Response to Submissions

Lourdes Retirement Village Planning Proposal

95 Stanhope Road, Killara

December 23, 2022

Figure 3: Existing village built form layout

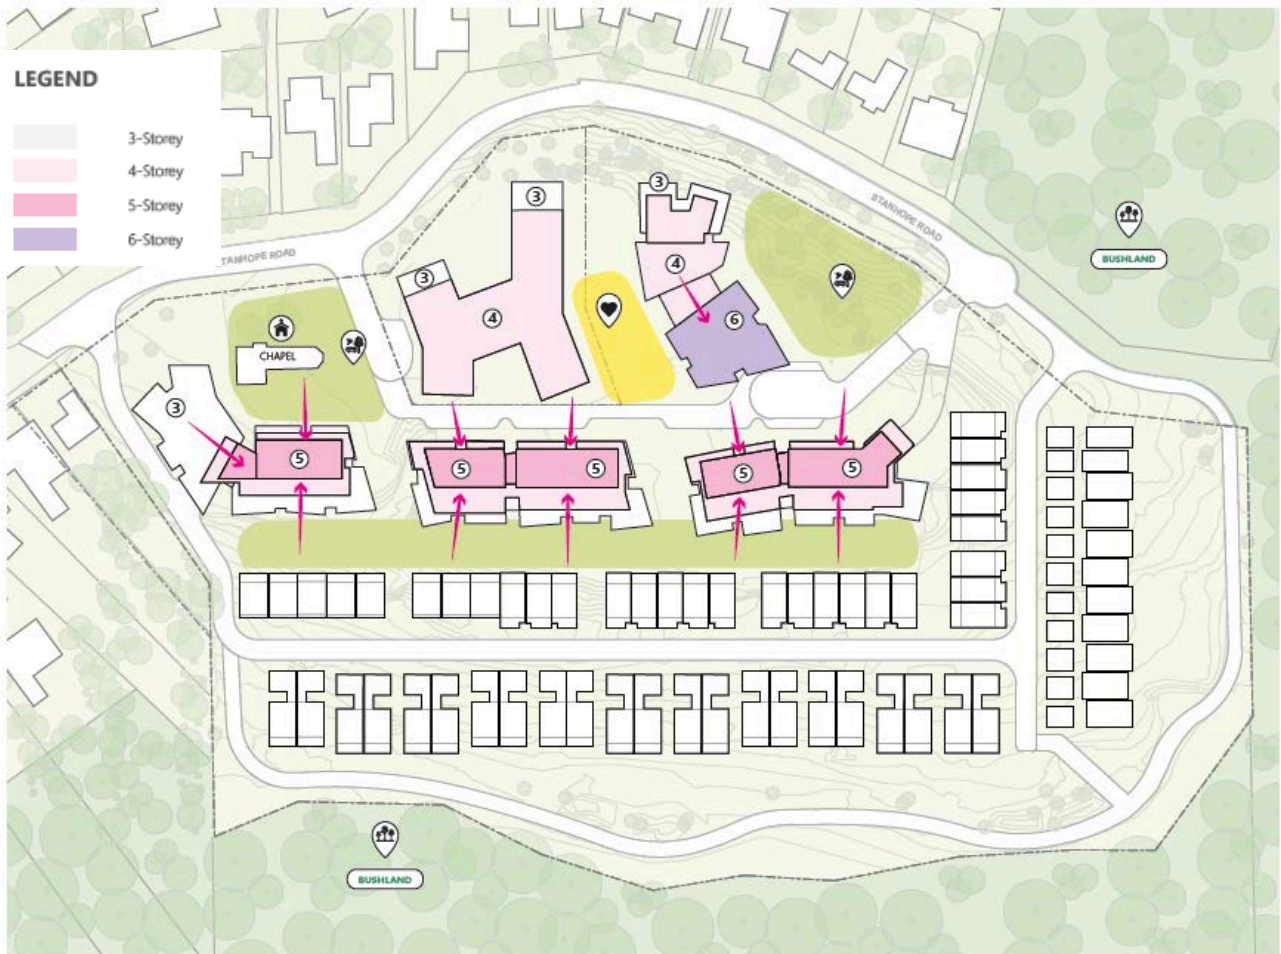
The exhibited Master Plan and amended Master Plan are shown in and Figure 1 and Figure 2 respectively and are also included in the Urban Design advice at Appendix A. Figure 3 shows the existing village layout.

Figure 4: Building height and upper-level setbacks

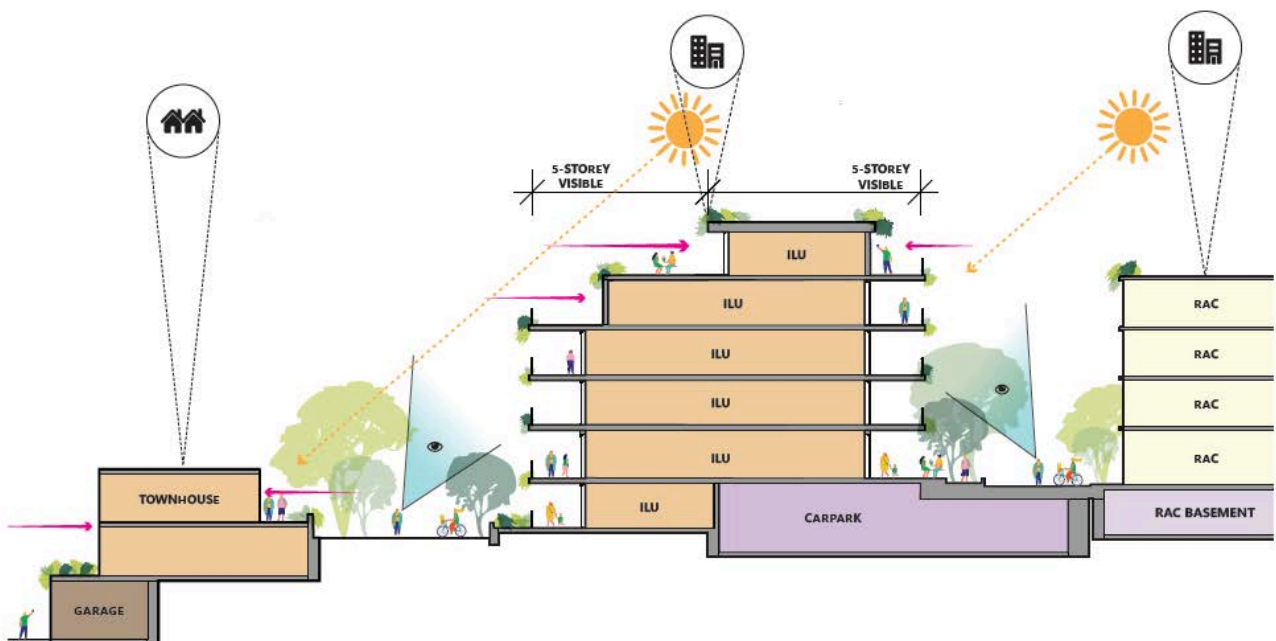
The changes in buildings heights and clarification of upper level setbacks is also illustrated at Figure 4, and Figure 5 highlights the proposed transition of scale across the site topography which seeks to minimise perceived height at ground level and maximise solar access.

Figure 6: Tree removal

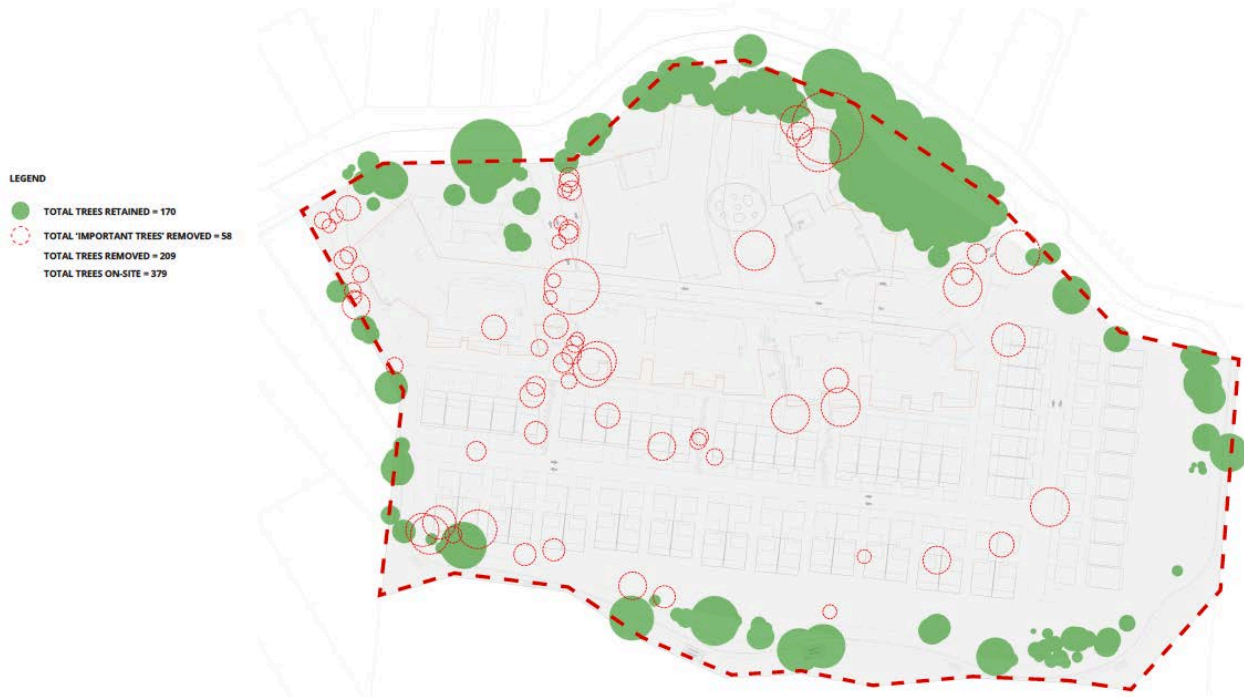
The updated Master Plan would result in removal of 209 trees compared to 233 under the exhibited Master Plan. This has been achieved through retention of additional trees around Headfort House and the southern and eastern perimeter of the site.

Figure 7: Tree planting

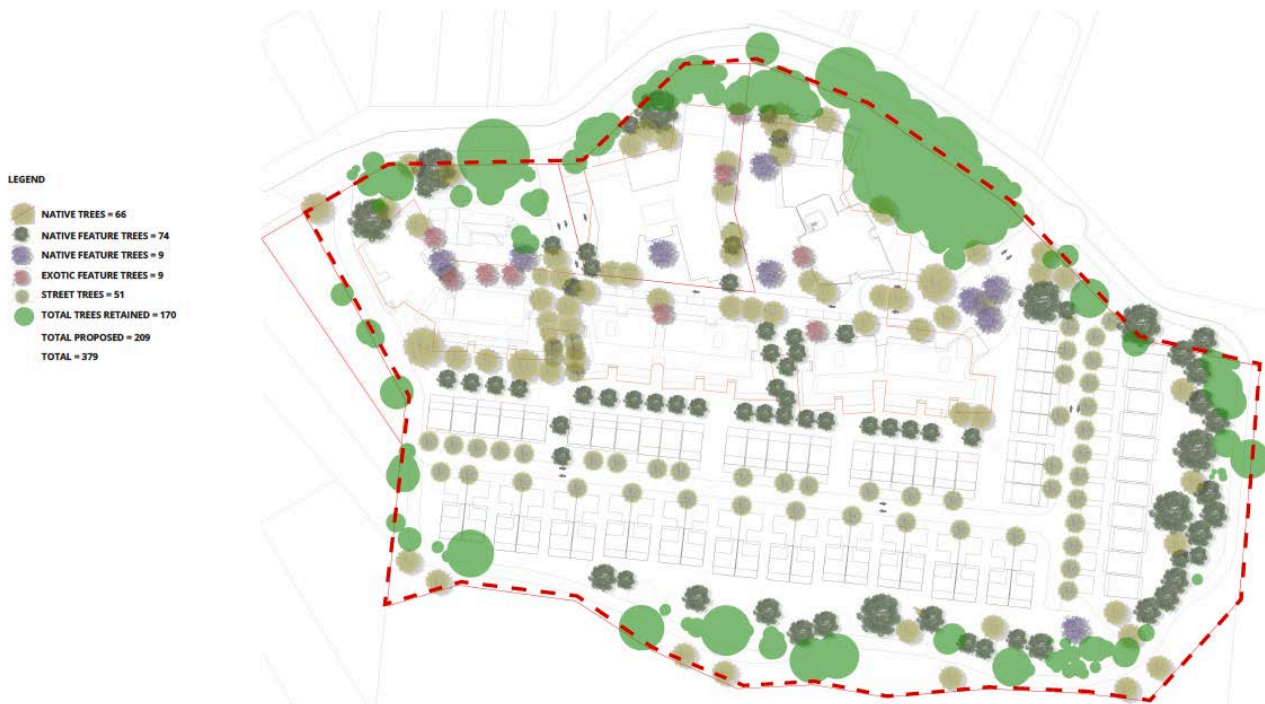
Of the 209 trees to be removed 58 are identified as significant trees with 151 being of low significance. A total of 170 trees would be able to be retained on site, with 209 trees proposed to be planted result in a total of 379 trees consistent with the existing number.

Figure 9: View P01 – Seven Little Australians Park

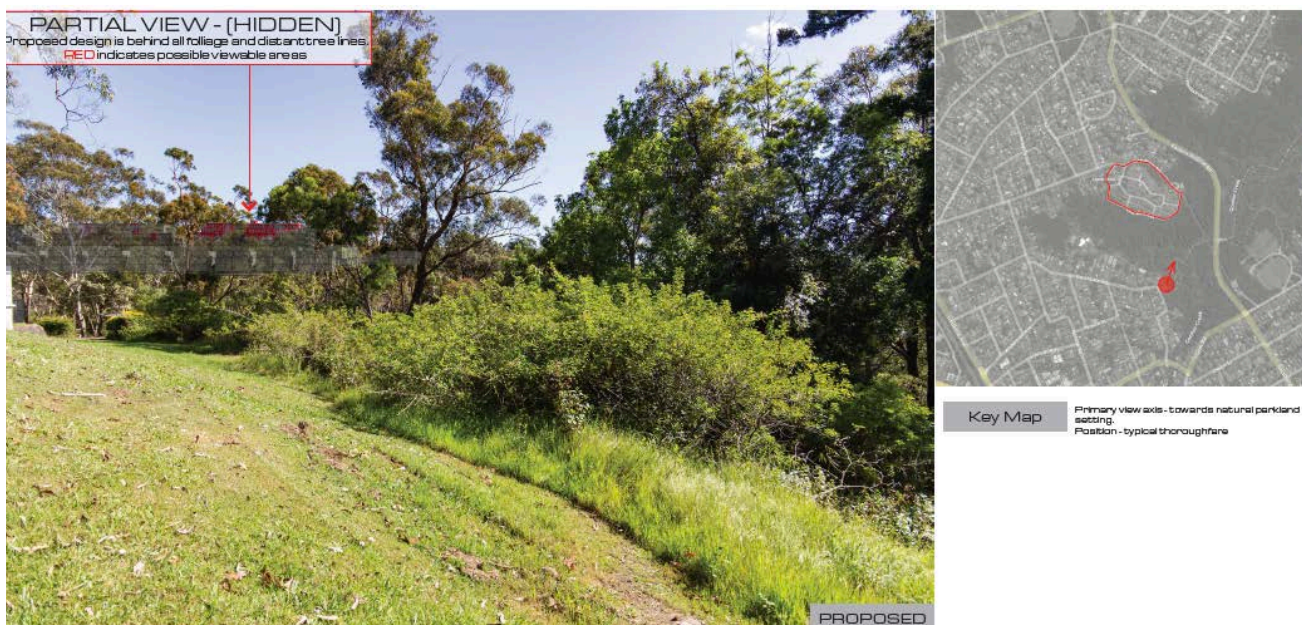
Numerous views have been assessed from the surrounding bushland including from Seven Little Australians Park and Swain Gardens. The views from Swain Gardens show that the proposed built form will be entirely hidden from view. For views within Seven Little Australians Park the proposed built form would be hidden from view with the exception of glimpses of rooftops through foliage from one vantage point at the entrance to the park (Figure 9). This is considered to be a minor impact.

Figure 11: View P08 – Rosebery Road at the intersection of The Crescent looking south

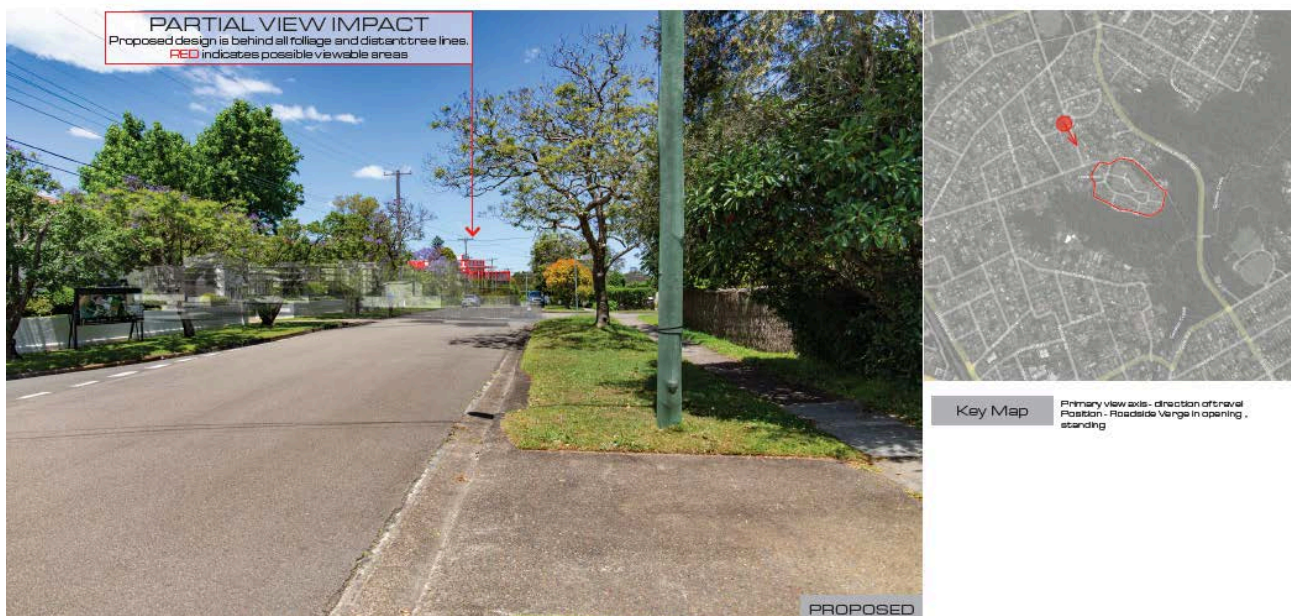
The tops of buildings will also be partially visible through and above foliage for longer range views from Stanhope Road at the intersection with Redgum Avenue looking east (Figure 10) and Rosebery Road at the intersection of The Crescent looking south (Figure 11). This is considered to be a minor impact.
